# CITY OF SUN VALLEY
# PLANNING AND ZONING COMMISSION
# AGENDA REPORT

**Agenda Item:** **Weyyakin Entry Signage and Landscaping Design Review Application No. DR 2014-28**

# (DRAFT) FINDINGS OF FACT AND CONCLUSIONS OF LAW
# CITY OF SUN VALLEY
# PLANNING AND ZONING COMMISSION
# DESIGN REVIEW

Project Name: **Weyyakin Entry Signage and Landscaping at Elkhorn Road**

6 STOP SIGN / STREET SIGN DETAIL
SCALE: 3/4" = 1'=0"

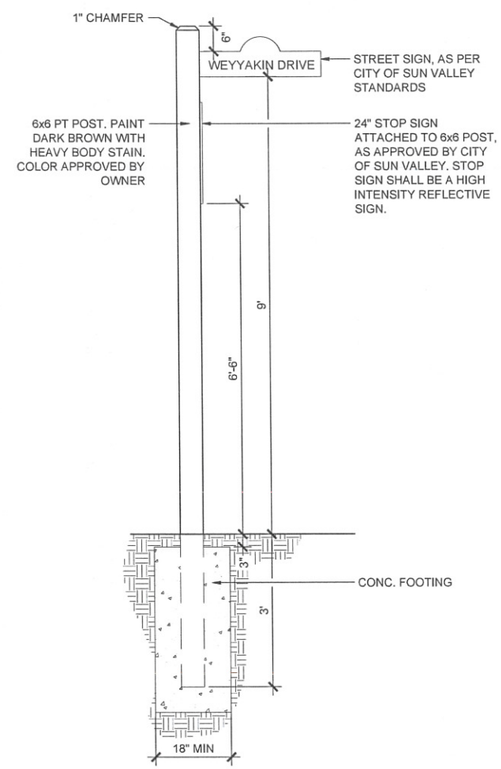
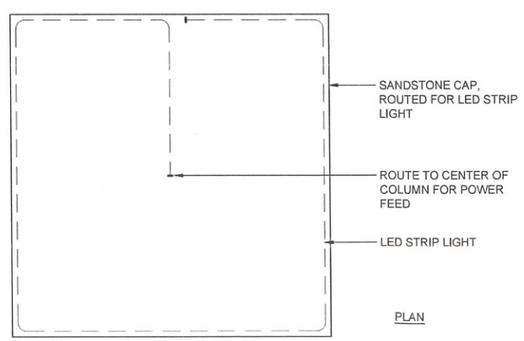
**Street Signs-** The proposed new street signs for the private cul-de-sac entries are conditioned to be consistent with the public street sign standards of the City of Sun Valley. The project drawings depict a new stop sign placed onto a 6" by 6" wood pole with a standard brown format street sign. City standards require that these two signs not be placed on the same pole for safety and visibility reasons. The project is conditioned to require that the new street sign and stop sign be placed on separate wood poles in consultation with the City's Streets Department.

8. **The project drawings show the existing street sign and stop sign to be replaced with a new street sign and stop sign placed on one 6" by 6" wood pole. As part of the project implementation, the street sign and stop sign shall be placed on separate poles for visual and safety purposes to the satisfaction of the City's Streets Department.**
